NEI 99-01 [Revision 67-DRAFT G]

Development of Emergency Action Levels for Non-Passive Reactors

**Development of
Emergency Action Levels
for Non-Passive Reactors**

Figure 9-F-4: PWR Containment Integrity or Bypass Examples

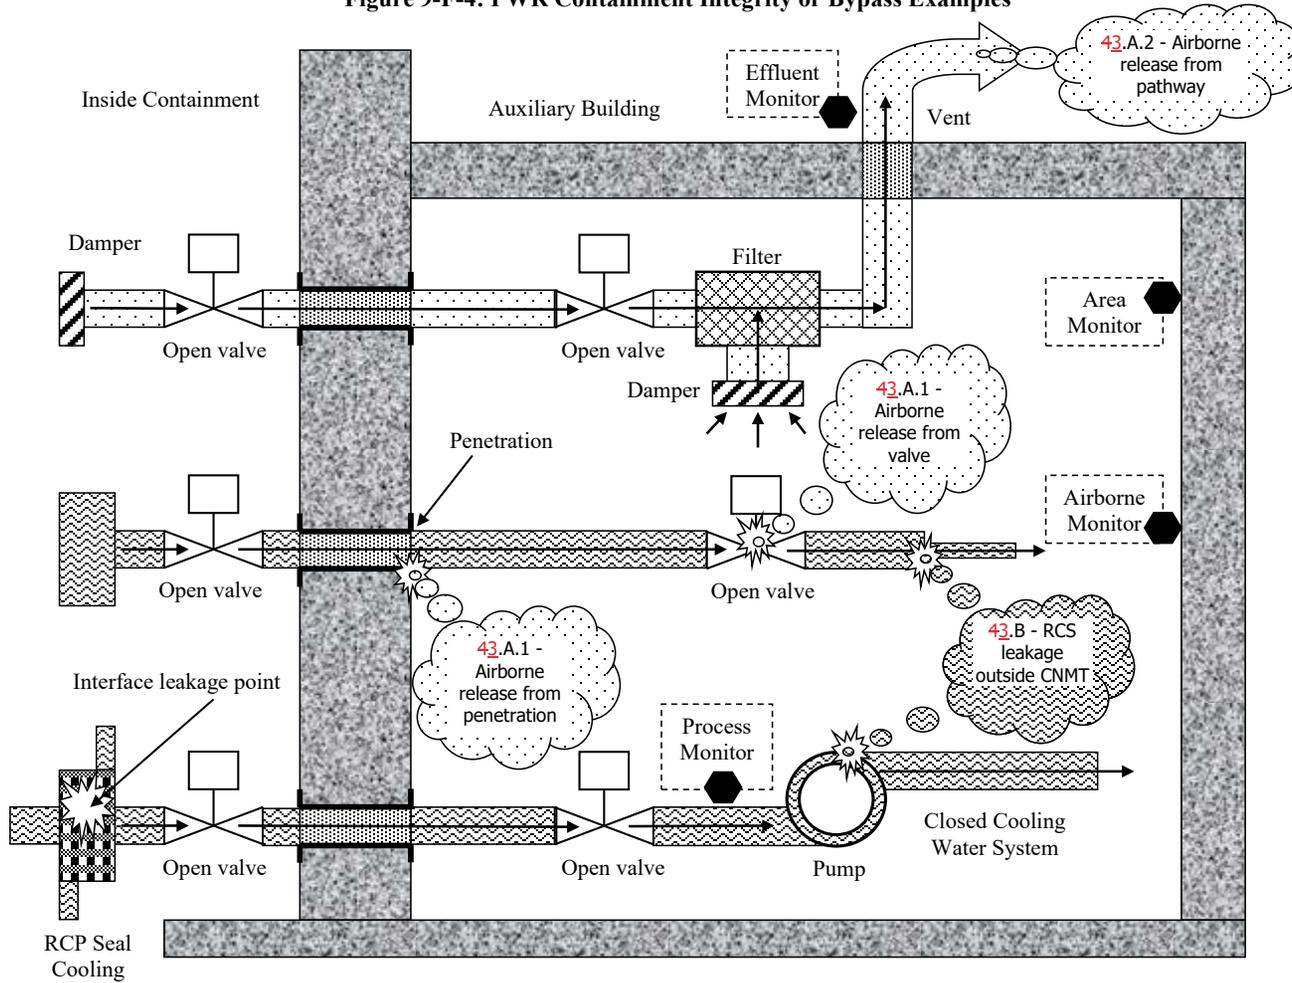
Refer to the middle piping run of Figure 9-F-4. Two simplified examples are provided. One is leakage from a penetration and the other is leakage from an in-service system valve. Depending upon radiation monitor locations and sensitivities, the leakage could be detected by any of the four monitors depicted in the figure.

Refer to the top piping run of Figure 9-F-4. In this simplified example, the inboard and outboard isolation valves remained open after a containment isolation was required (i.e., containment isolation was not successful). There is now an UNISOLABLE pathway from the containment to the environment.

Refer to the bottom piping run of Figure 9-F-4. In this simplified example, leakage in an RCP seal cooler is allowing radioactive material to enter the Auxiliary Building. The radioactivity would be detected by the Process Monitor. If there is no leakage from the closed water cooling system to the Auxiliary Building, then no threshold has been met. If the pump or system piping developed a leak that allowed steam/water to enter the Auxiliary Building, then threshold 43.B would be met. Depending upon radiation monitor locations and sensitivities, this leakage could be detected by any of the four monitors depicted in the figure and cause threshold 43.A.1 to be met as well.

Refer to the middle piping run of Figure 9-F-4. In this simplified example, a leak has occurred at a reducer on a pipe carrying reactor coolant in the Auxiliary Building. Depending upon radiation monitor locations and sensitivities, the leakage could be detected by any of the four monitors depicted in the figure and cause threshold 43.A.1 to be met as well.
